12555  
6 December 2012

**MP10\_0127 AND MP10\_0128 - MODIFICATION APPLICATION NO. 1  
ROPES CREEK EMPLOYMENT PRECINCT**

On behalf of Jacfin we hereby submit an application pursuant to section 75W of the *Environmental Planning and Assessment Act, 1979* (EP&A Act) to modify Concept Plan Approval MP10\_0127 and Project Approval MP10\_0128 relating to the development of an industrial estate for light industry, warehouses and distribution centres at Ropes Creek.

Surveyor: CAMERON PHILLIP MILES Date of Survey: Surveyor's Ref: SYDW 104650DP	PLAN OF SUBDIVISION OF LOT 121 DP1175762	LGA: BLACKTOWN Locality: ROPES CREEK Subdivision No: Lengths are in metres. Reduction Ratio 1:5000	REGISTERED	DP
---	--	---	------------	----

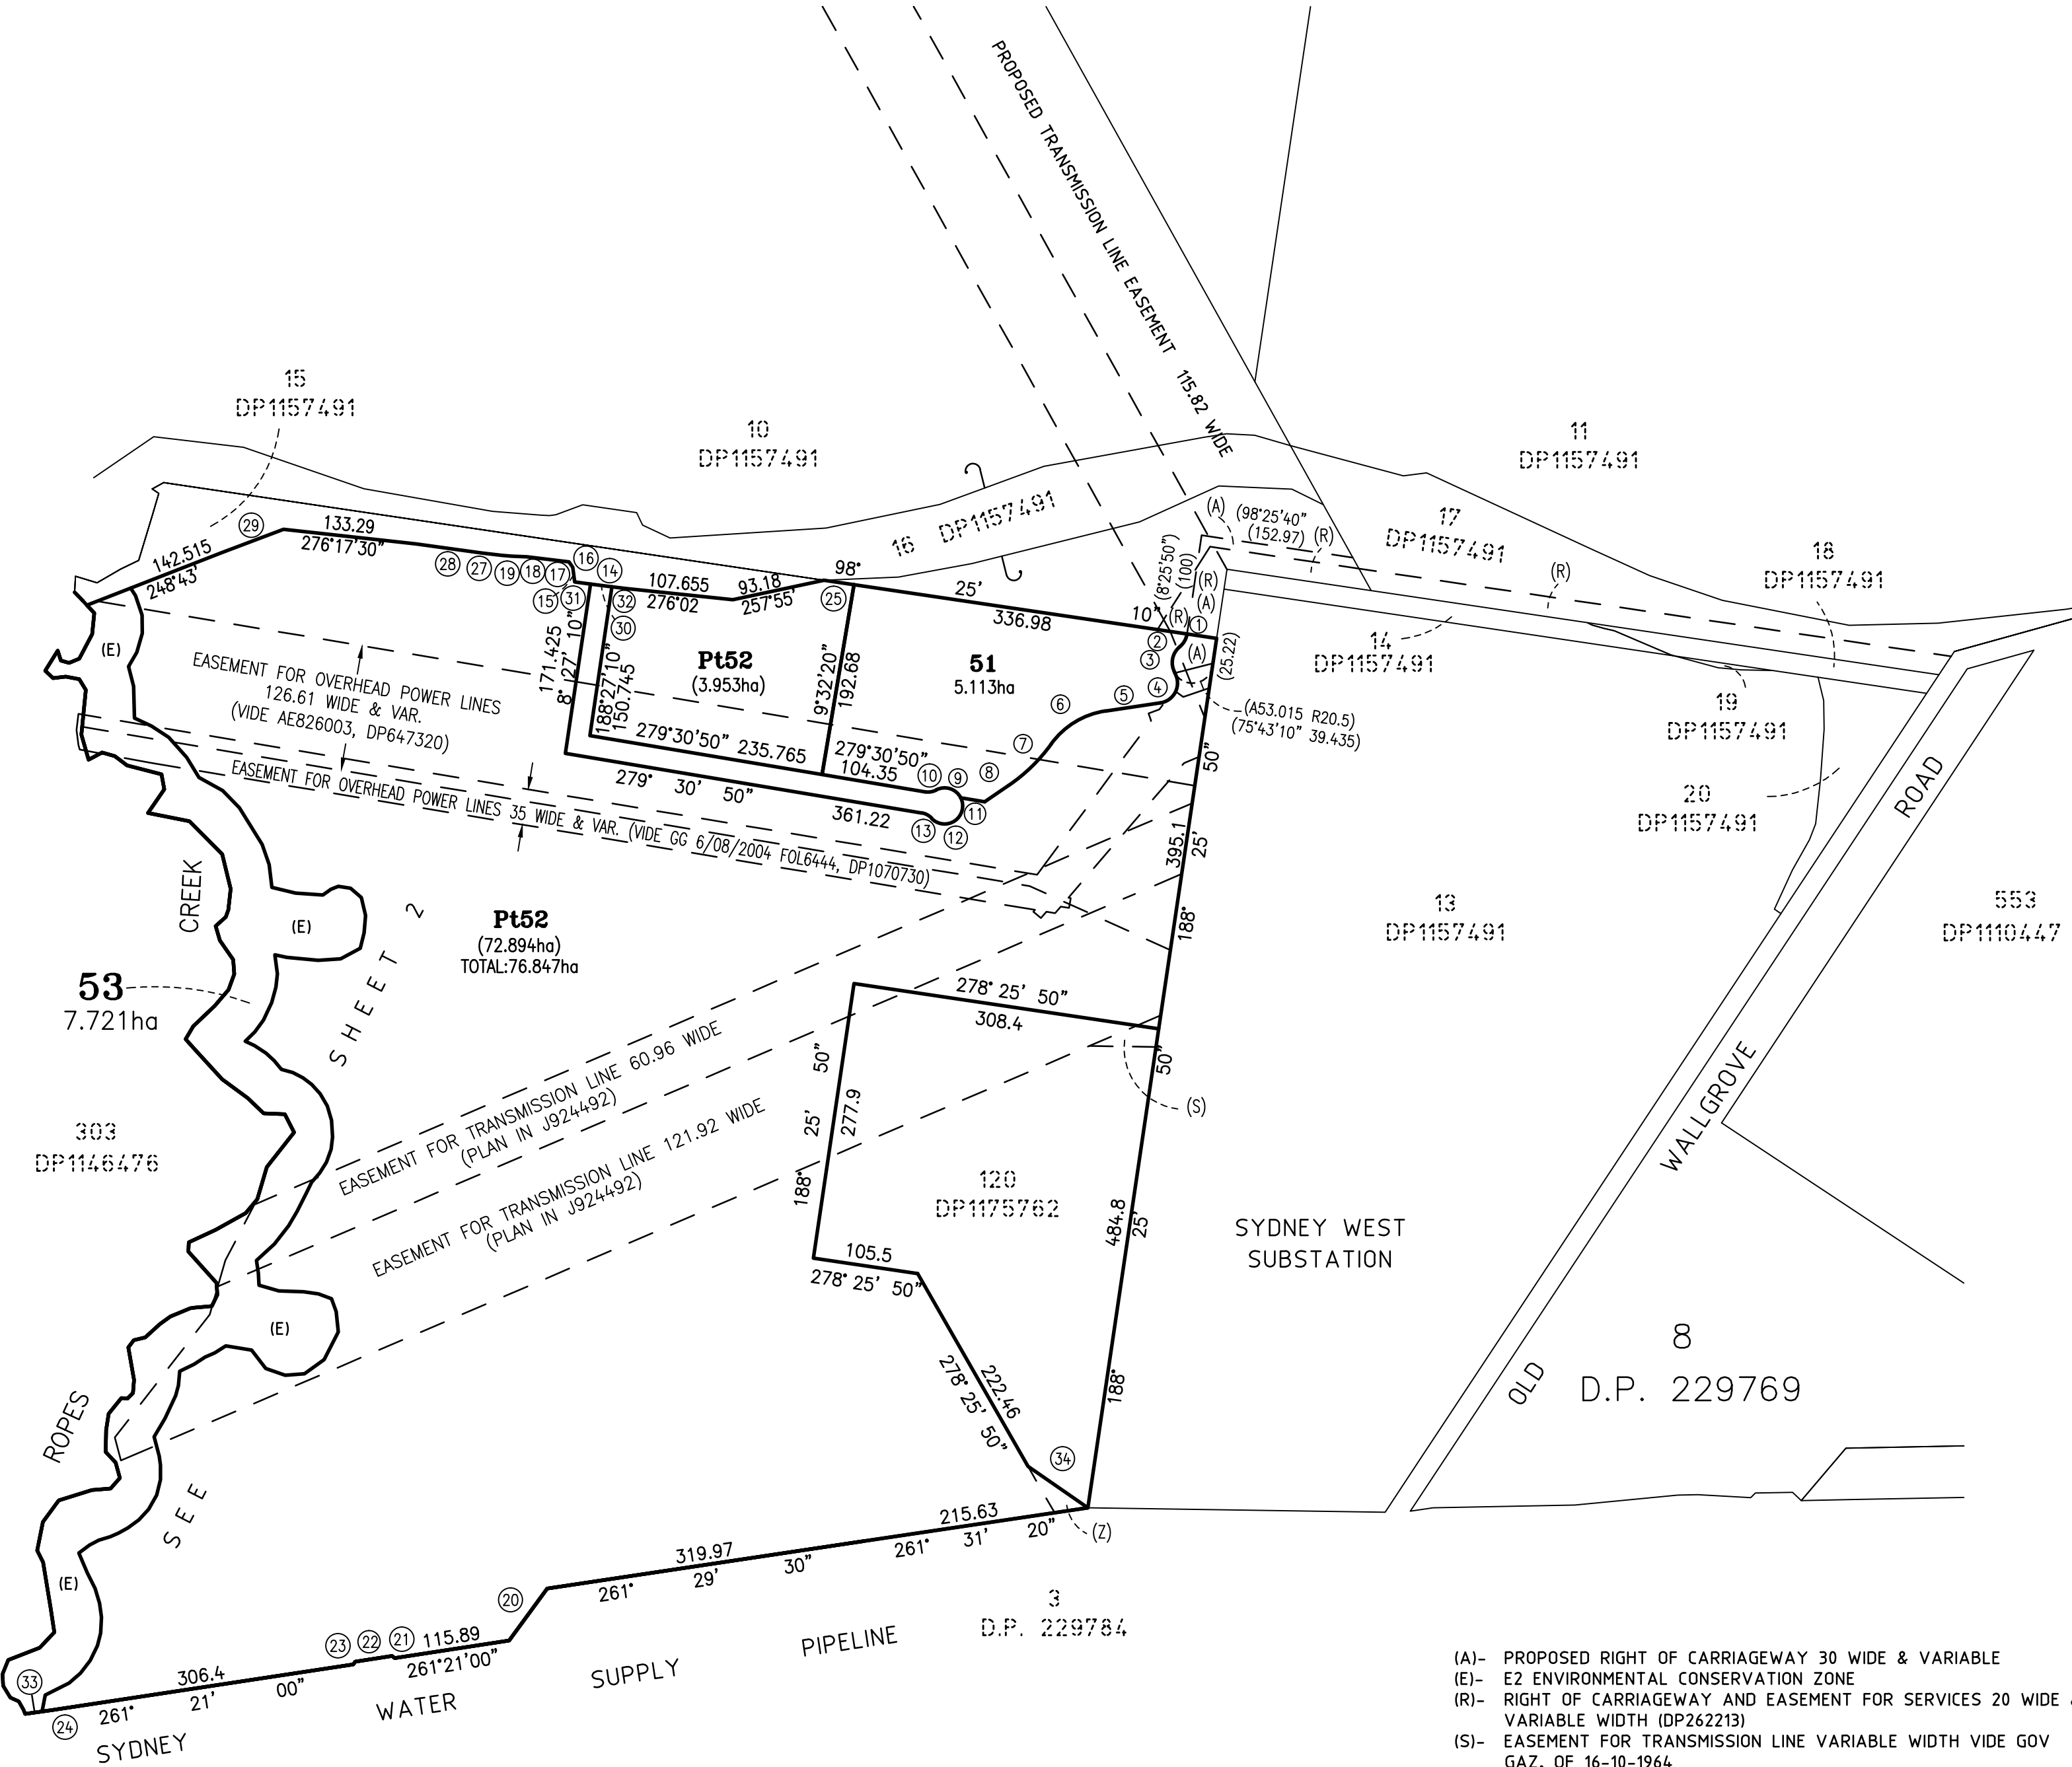
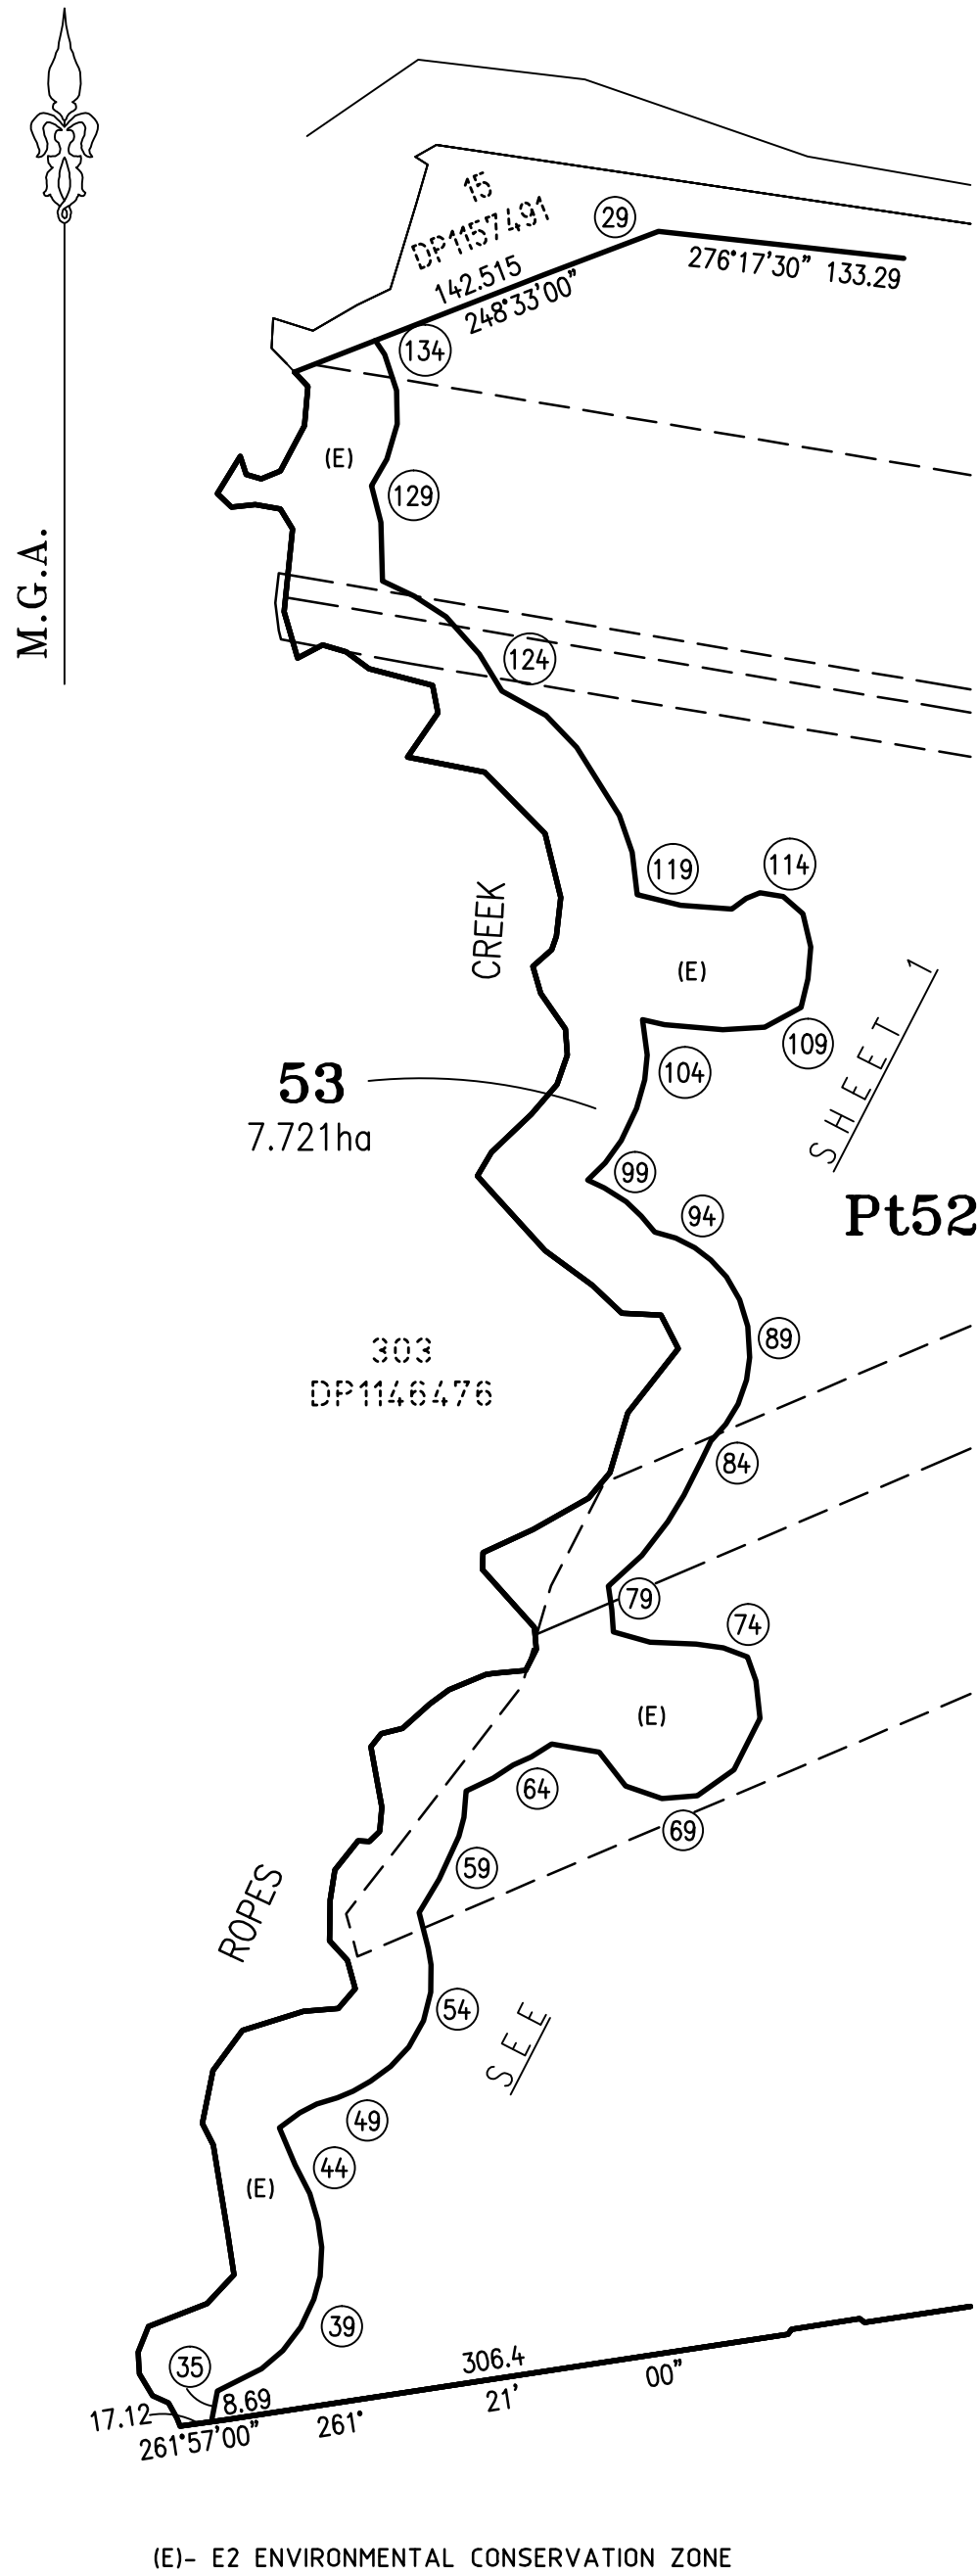
- Removal of Lot 120 DP 1175762 from the land to which the Stage 1 relates including a revised plan of subdivision (see **Attachment B**).
- Removal of Warehouse Building 1 in the southeast part of the site.
- Removal of Local Road 1 as it is no longer required for access to the southeast part of the site.
- Truncation of Local Road 2 west of the E2 zone as it is no longer required to connect to Local Road 1.
- Renaming of Warehouse Building 2 (located in the northeast corner of the site) to the Stage 1 Building.

- Amend Appendix A Site Plans as follows:
  - Remove PA01 Stage 1 PA Plan with version dated 31 October 2012 (provided in **Attachment B**).
  - Remove plans relating to Warehouse Building No. 1 on pages 11, 12, 13 and 14 of the Project Approval.
- Remove Draft Plan of Subdivision in Appendix B and replace with the revised Draft Plan Subdivision provided in **Attachment B**.
- Amend Commitment No. 5, remove Commitments No. 9 and No. 10 in Appendix C, because there is no longer a need to construct a crossing over the E2 Zone, and insert a new Commitment No. 9, to address internal driveway arrangements, as follows:
